ADDENDUM #1

PROJECT NAME: SCCAD Headquarters

CLIENT NAME: St. Charles County Ambulance District

PROJECT NO.: 18007

Revision
No. 1
Date: 11/06/19
City of St. Peters submittal
12/13/19 per City of St. Peters comments
12/18/19 Addendum #1
Project No. 18007
Sheet No. C10.1
12/02/2019

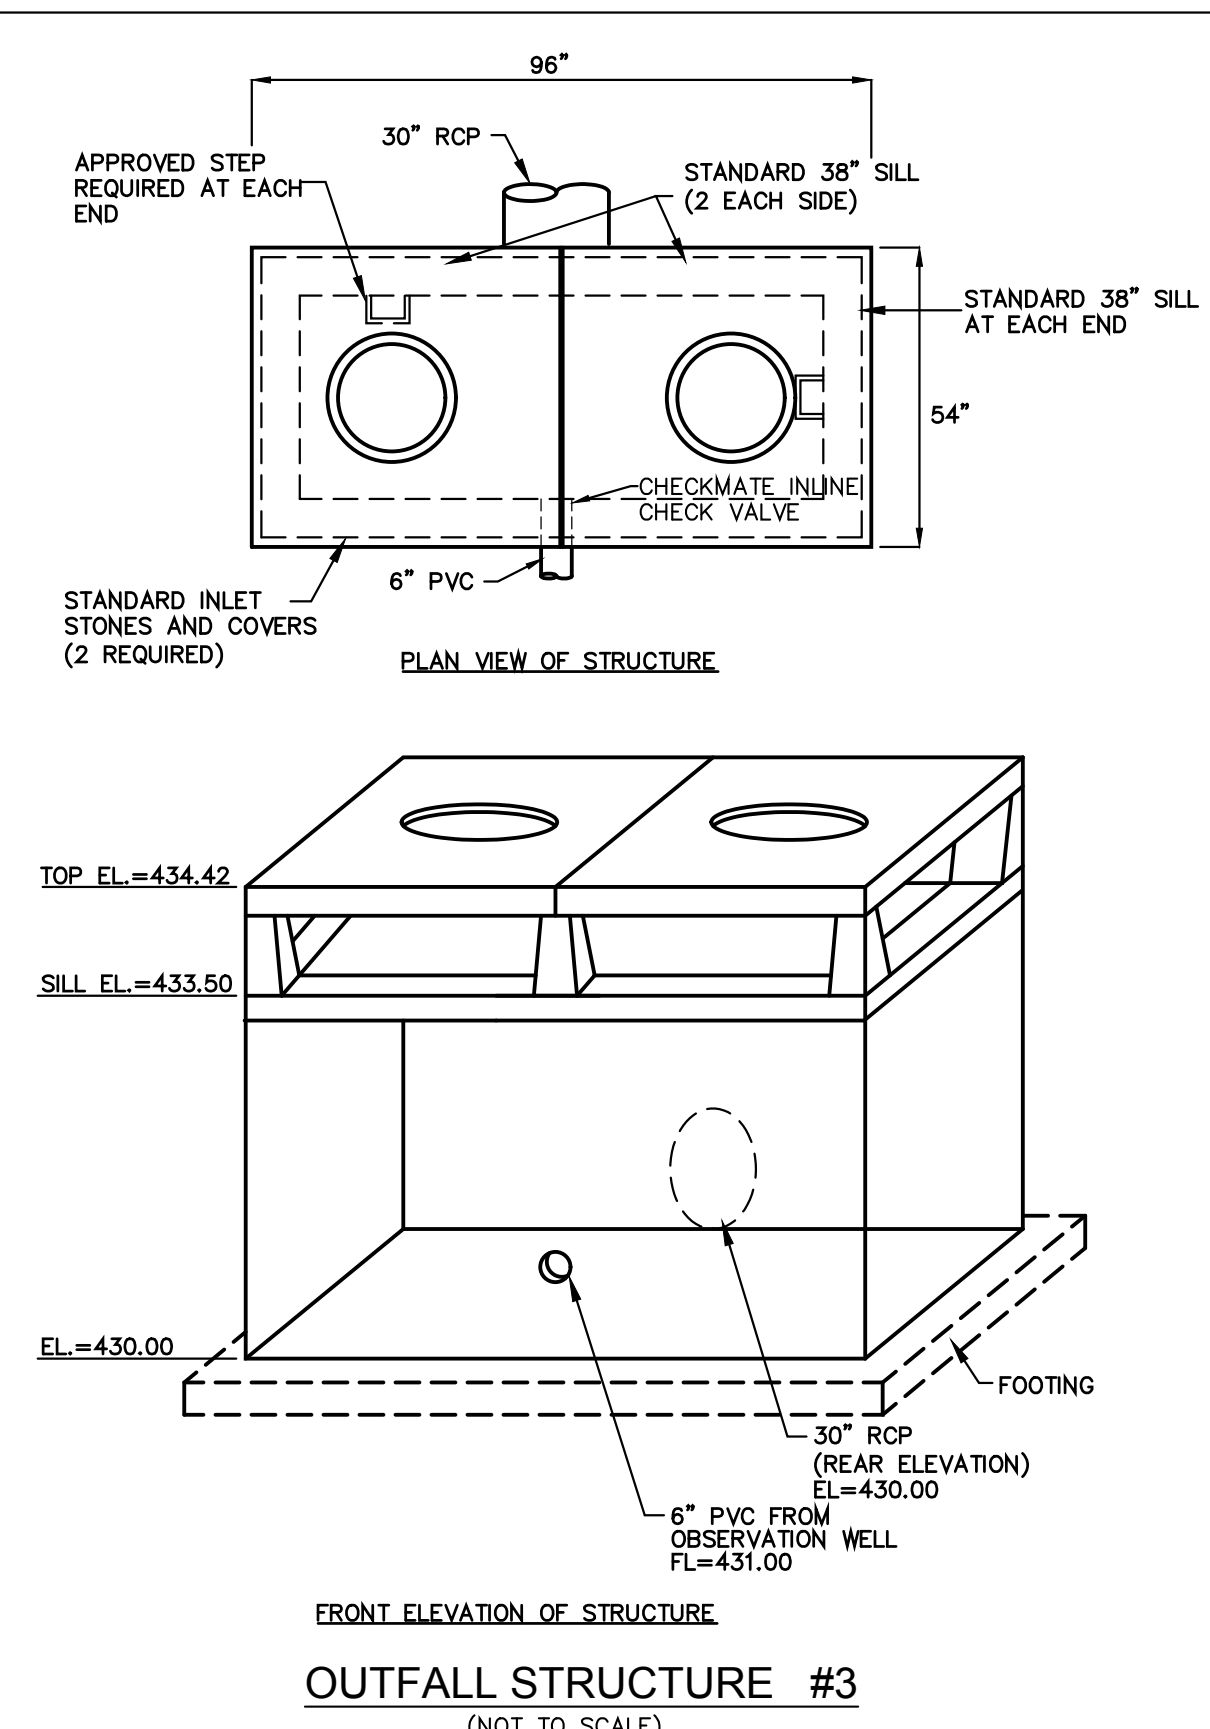
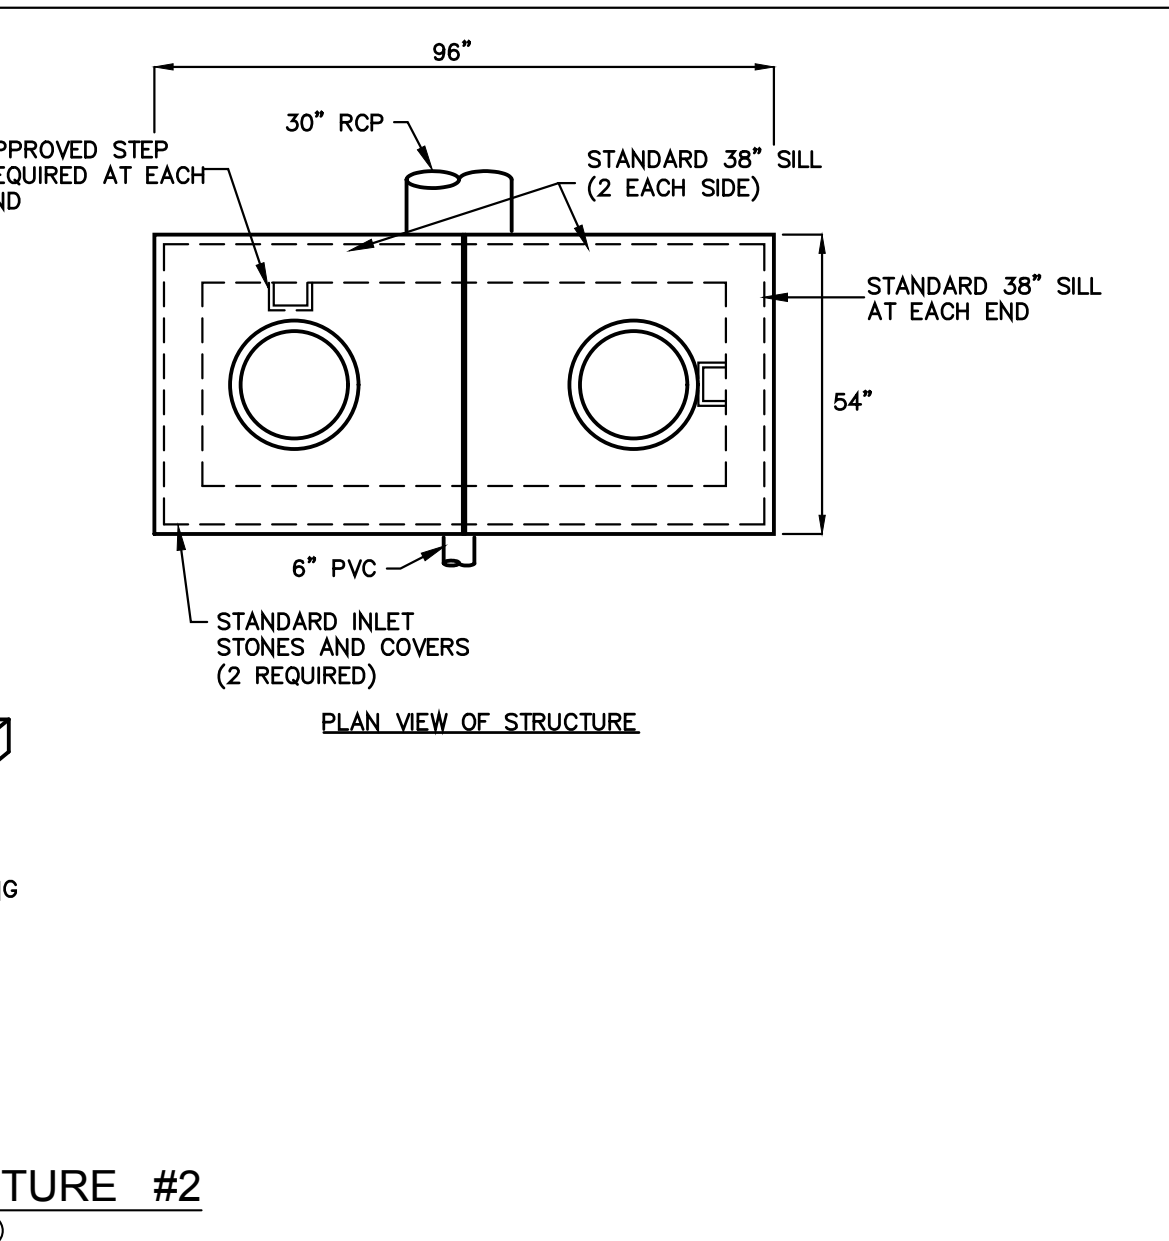
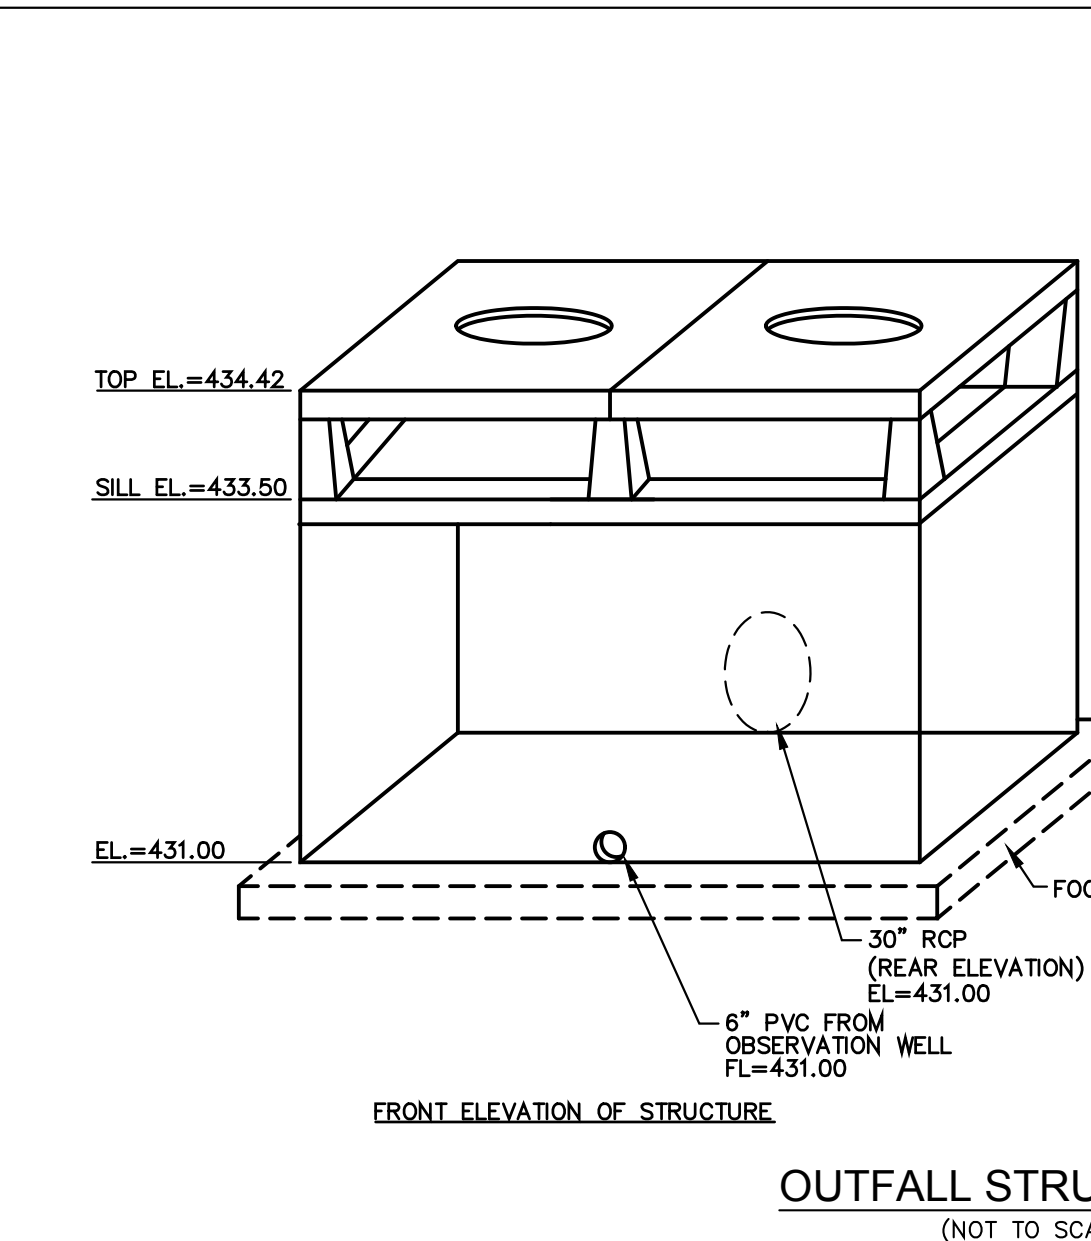
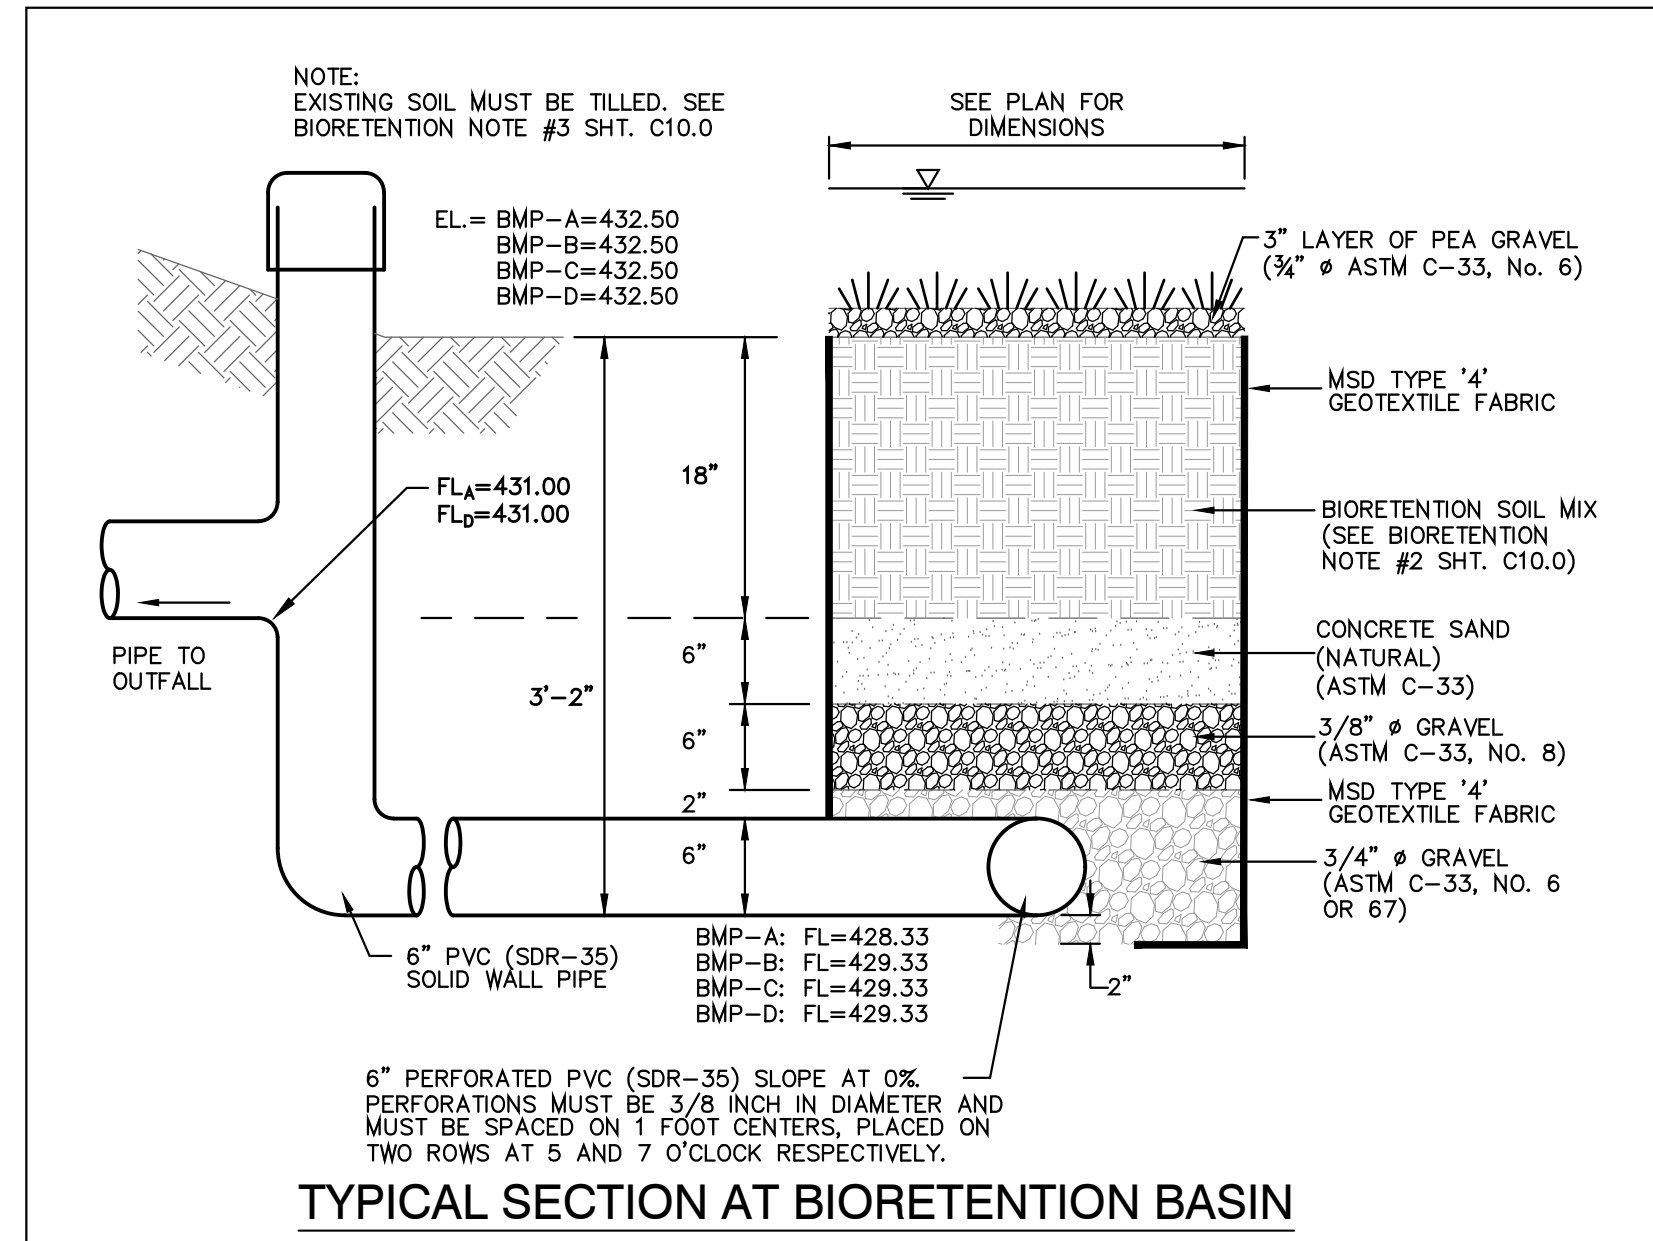
Sheet C10.1

1. Revise section A-A at bioretention basin D (remove equalizer pipe) SHEET C02:

Project No. 18007
Sheet No. **A143**
Date 12/02/2019

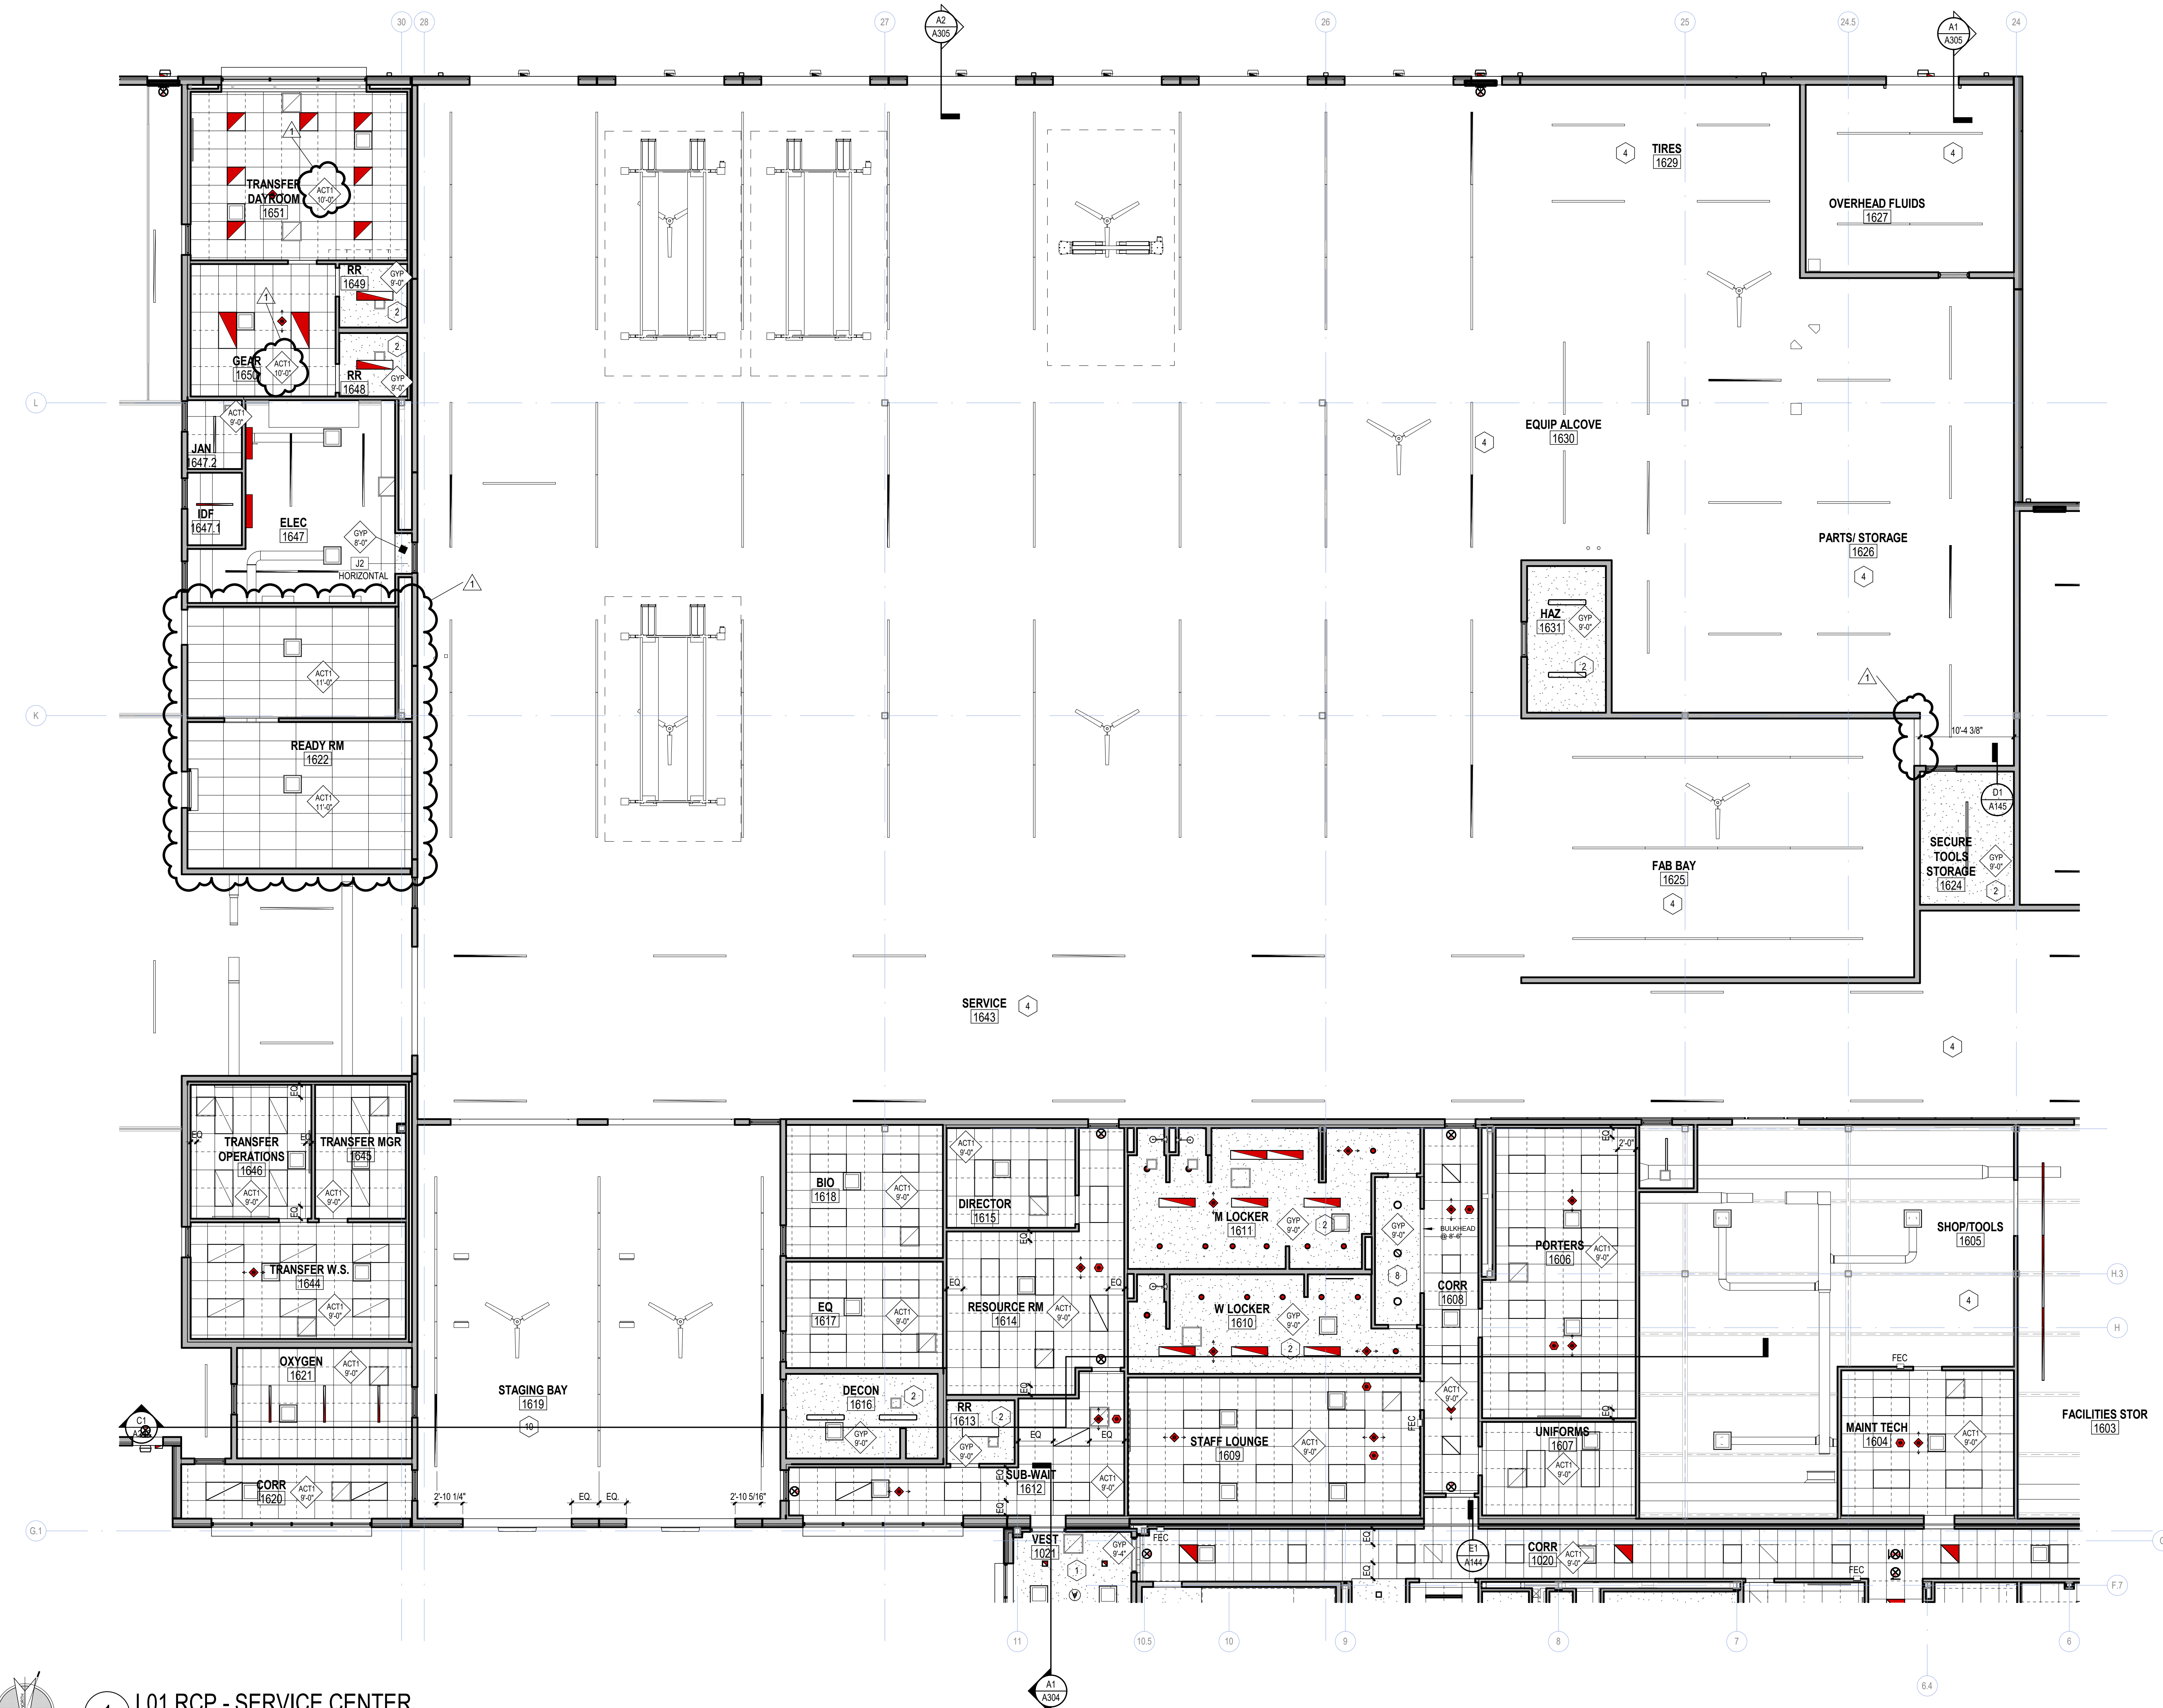
SHEET A143

- REVISED – Ceiling heights – Transfer Dayroom 1651 and Gear 1650
- ADD – ACT1 ceiling Ready Room 1622
- ADD – Bulkhead between FAB Bay 1625 and Parts / Storage 1626
